Service Bulletin

Subject: Brake Pedal Squeak Noise Heard When Applying and Releasing Brake Pedal

Brand:	Model:	Model Year:		VIN:		Engine:	Transmission:
		from	to	from	to		
Chevrolet	Volt	2016	2017

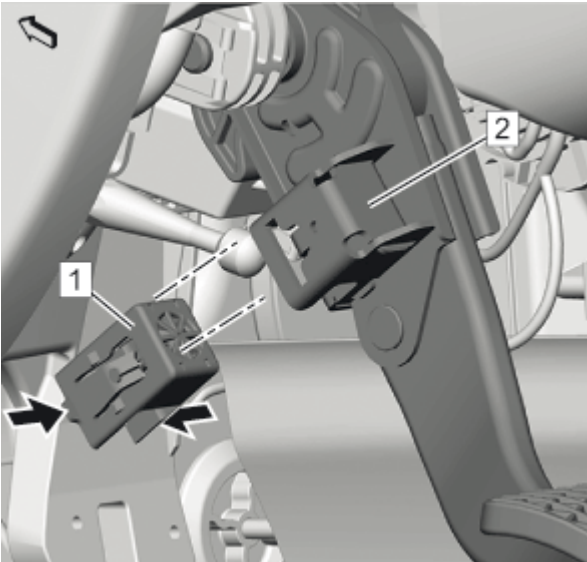
- Loosen both bolts at the power brake booster.
Important: **DO NOT** remove the brake master cylinder reservoir to get access to the power brake booster bolts.
- Remove the brake pedal position sensor. **The brake pedal sensor MUST be removed.** Refer to *Brake Pedal Position Sensor* in SI.

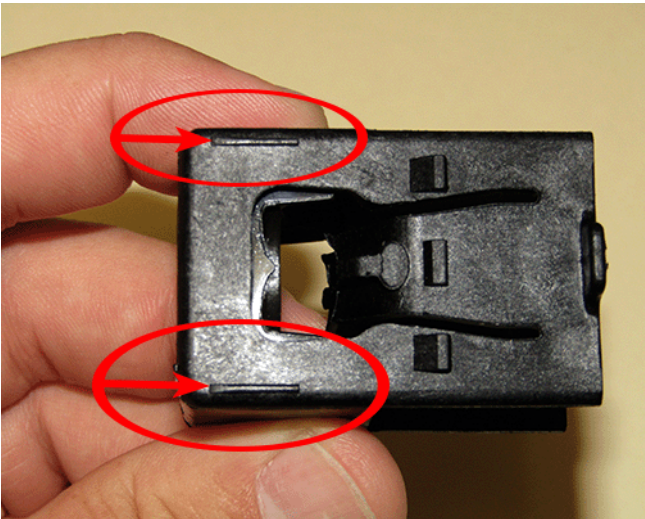
3. Disconnect the brake pedal push rod (1) from the brake pedal (2). Press the two tabs of the brake pedal push rod retainer (3) together and pull the brake pedal to facilitate the removal.

4. Remove and **DISCARD** the brake pedal push rod retainer (1) from the brake pedal (2).
5. Install the **NEW** brake pedal push rod retainer into the brake pedal by hand using reasonable effort.

Note: The new retainer has two raised ears on both sides located on the front, which will cause an interference fit when installing.

Replace the brake pedal push rod retainer with the new design part following the Service Procedure listed below.
